Date: December 11, 2018

RE: Response to USEPA Request for Alternate Purging and Sampling Method for Long-Screen Wells
Army Creek Landfill Superfund Site, New Castle County, Delaware

PROPOSED WESTERN LOBE MONITORING WELL LOCATIONS

FIGURE 2

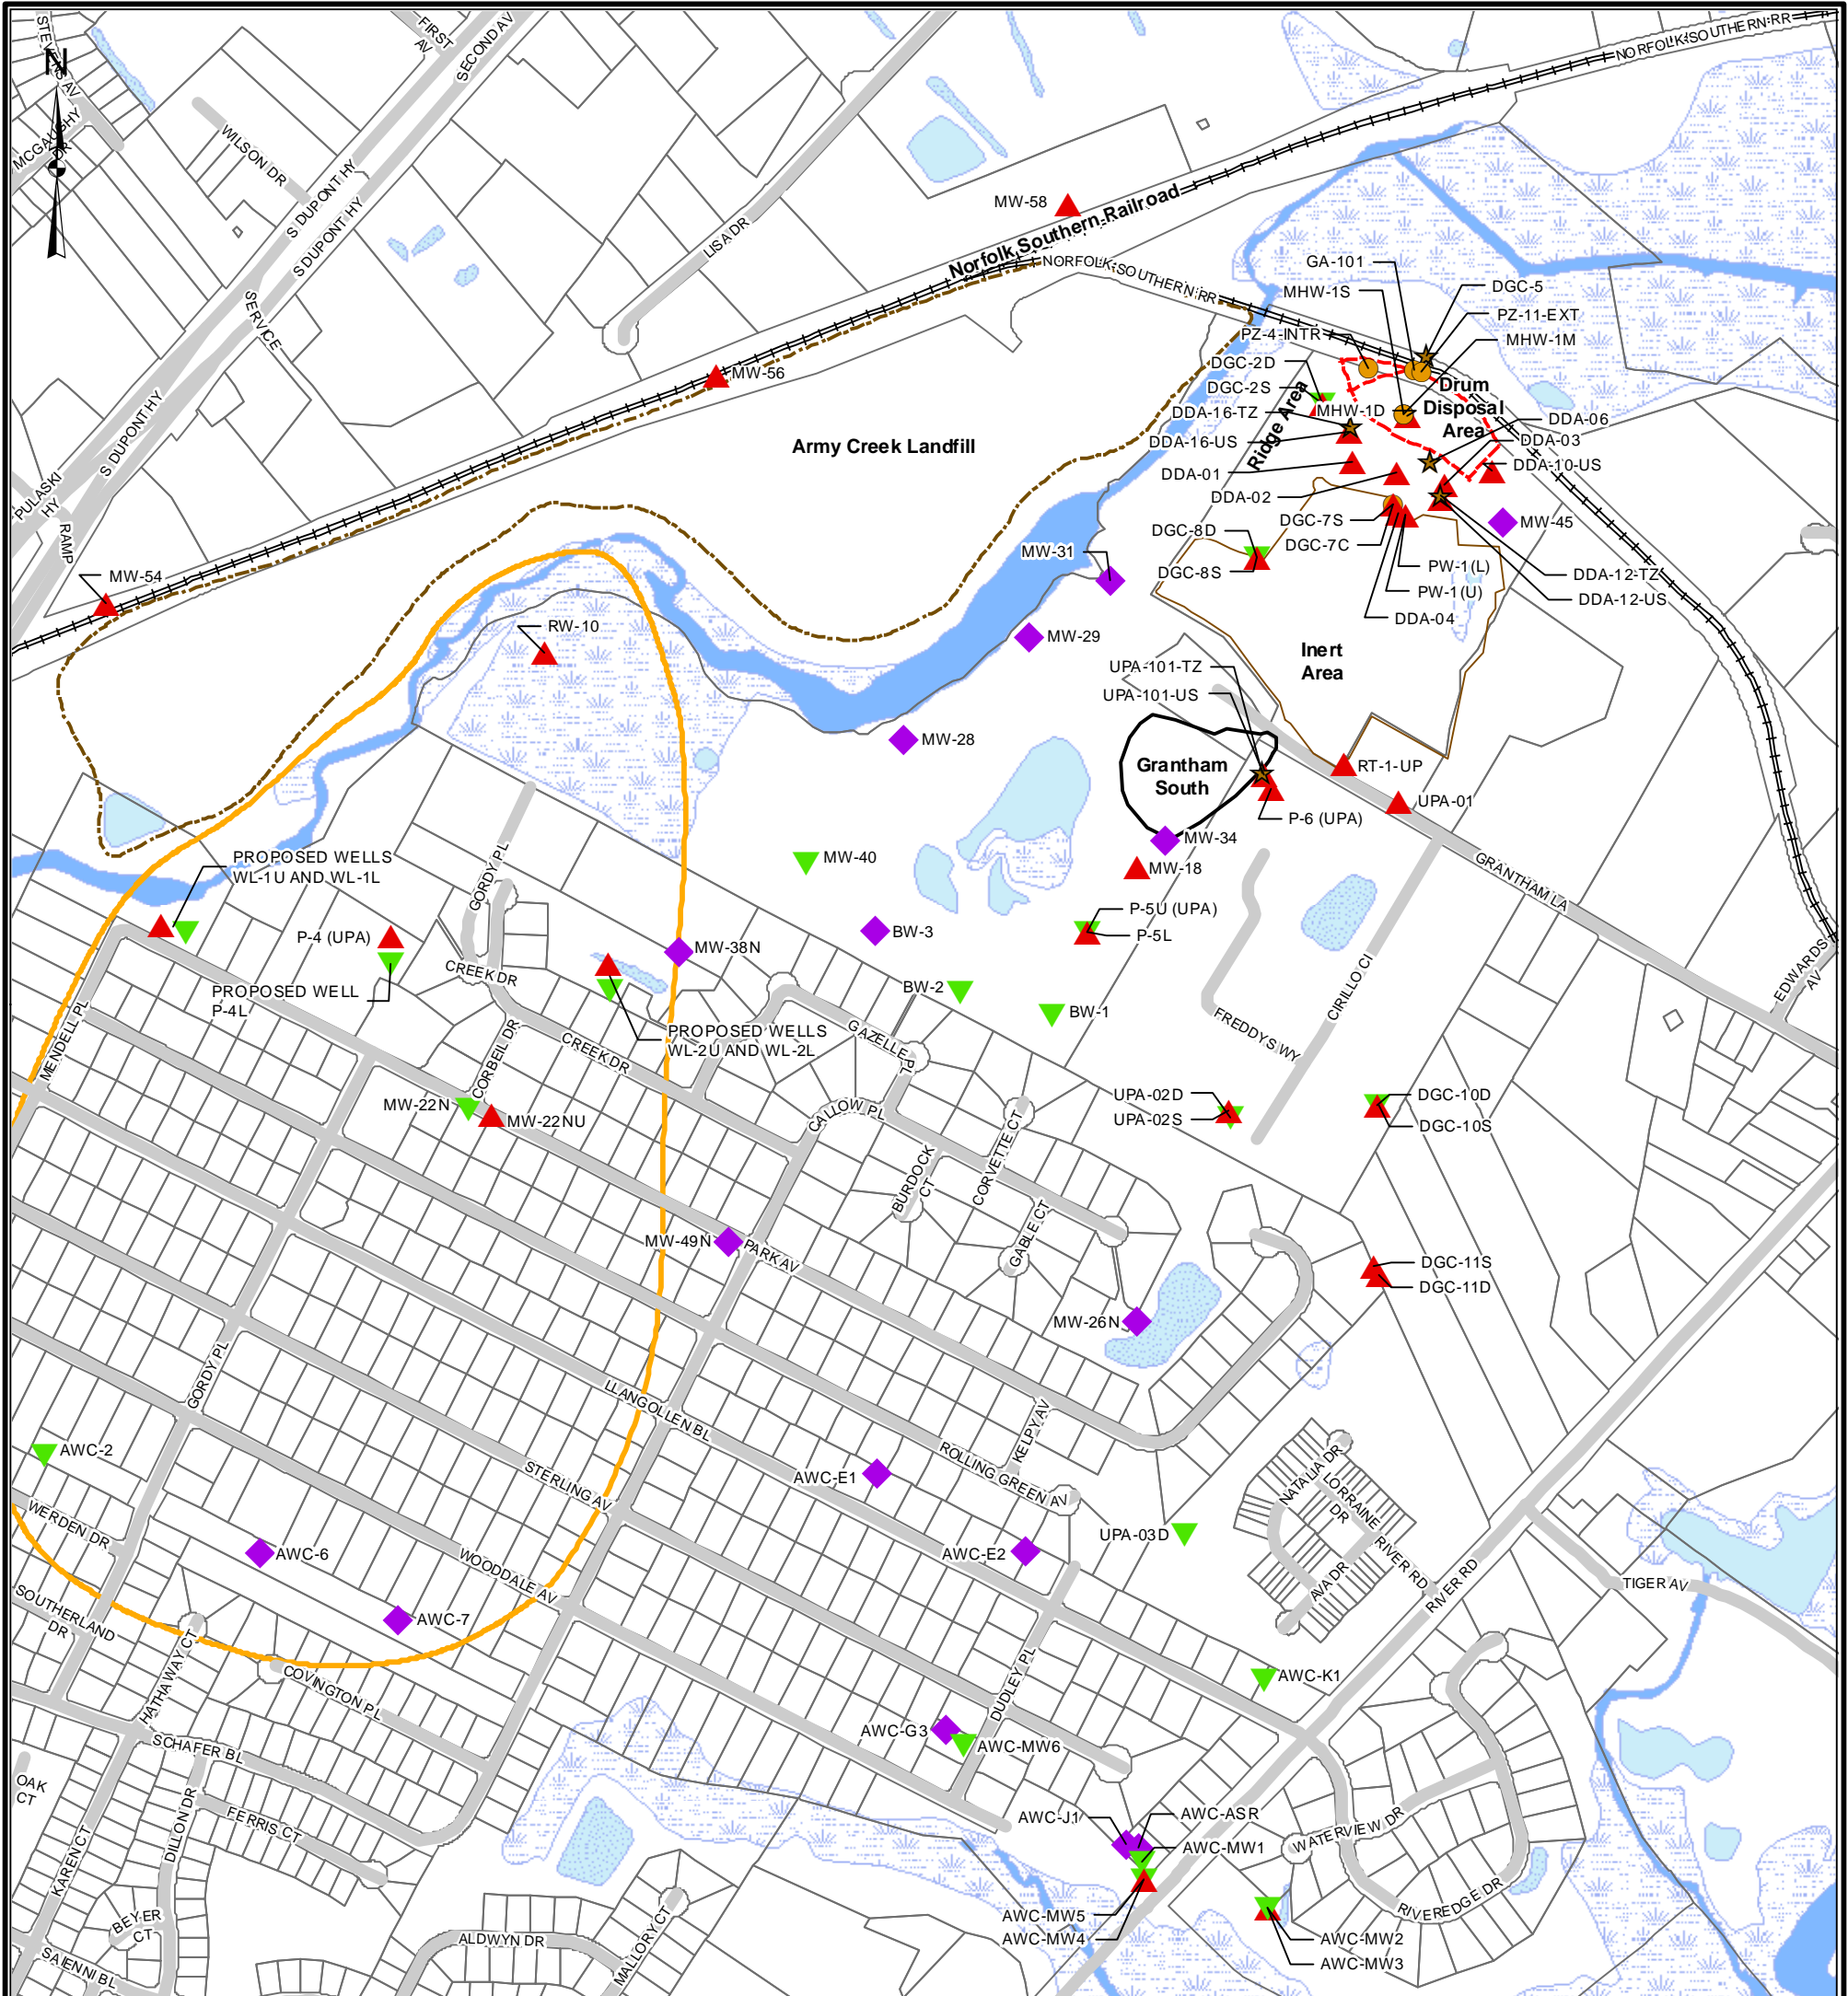
On behalf of New Castle County (NCC) and the Army Creek Private Settlers (ACPS), Golder Associates Inc. (Golder) and Ruth Associates Inc. (RAI) prepared this response to the United States Environmental Protection Agency's (USEPA's) Comments 16 and 24 dated April 24, 2018 and subsequent correspondence (June 1, 2018 Response-to-Comments document by Golder and RAI) and discussions (July 25, 2018 teleconference and September 20, 2018 meeting) regarding long-screened wells and low flow sampling procedures for the Army Creek Landfill Superfund Site (Site) located in New Castle County, Delaware. This memorandum and attached table were prepared in response to these comments and discussions.

Based on discussions between the USEPA and the Site representatives regarding the appropriate purging and sampling techniques for long-screen wells, the revised Additional Investigation Work Plan and Sampling and Analysis Plan (SAP) will include use of low-flow purging and sampling techniques consistent with historical practices combined with collection of a subset of samples using volumetric averaging (3-well-volume purging followed by sample collection). A table summarizing the construction of the wells in the monitoring program and the sampling methods is attached.

- Wells in key locations for conceptual site model (CSM) development with particularly long screens or potential significant heterogeneity within a long screen were targeted for comparison. These areas and wells include:
 - Western Lobe Study Area: P-4 and MW-22N
 - Screened across both UPA upper and lower sand: BW-3, MW-28, MW-29, and MW-31
 - PFAS Evaluation: MW-28, MW-29, MW-31 and MW-58
- Wells selected by DS&G for a similar volume averaging evaluation were not selected.
